## **Response to Referee #1's comments**

### **Response to Referee #3's comments**

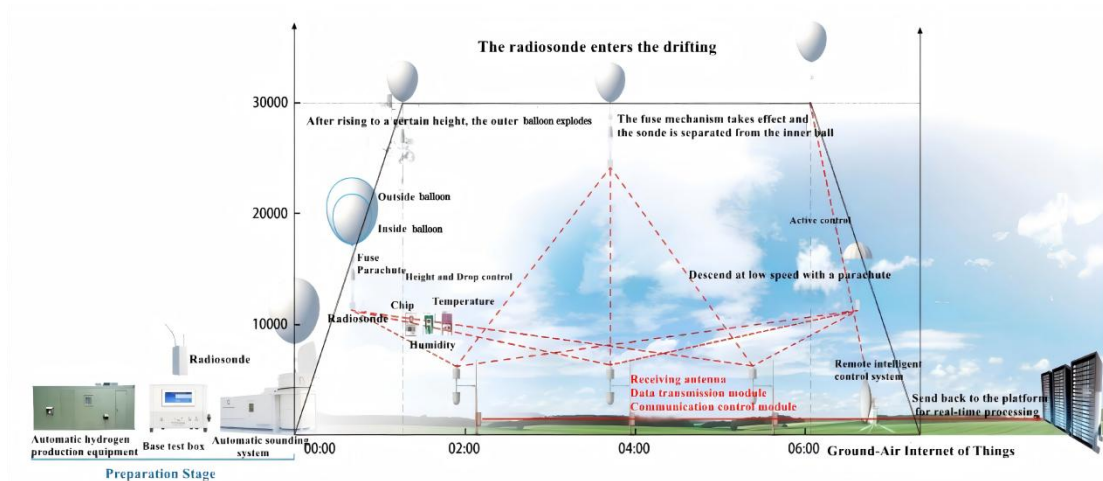
15)Figure 1. It would be more consistent to refer to "*balloon*" rather than "*ball*"

**Authors:** - This is a translation mistake, we carefully examined the entire text, redraw Figure 1 on [Page 3, L94] and [Page 13, L358] of the revised manuscript as follows:

Figure 7. Schematic diagram of the observed (black) and simulated (red) trajectories. The yellow pentagram indicates the radiosonde station. The color of each point represents the

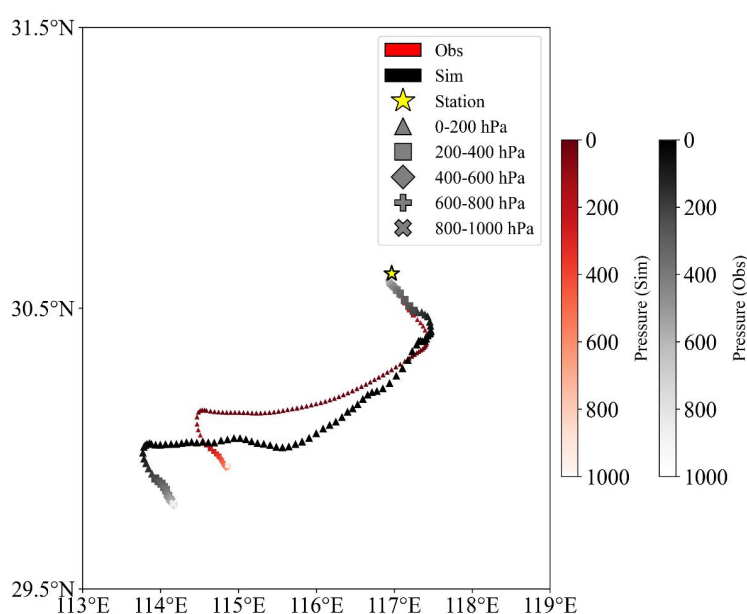
358 "A color gradient based on pressure altitude" The colour gradient is too subtle for me to make out. Use different (larger) markers when a multiple of 200hPa is crossed?

**Authors:-** Thank you for your valuable suggestions. The simulated trajectory refers to the forecast data generated by the Beidou-based radiosonde trajectory prediction system. We acknowledge that color gradients alone may be difficult to distinguish. Therefore, we have revised the Figure7 to use distinct and larger markers at every 200hPa interval, which is clearly indicated in the legend for better clarity. in L372 of revised manuscript.
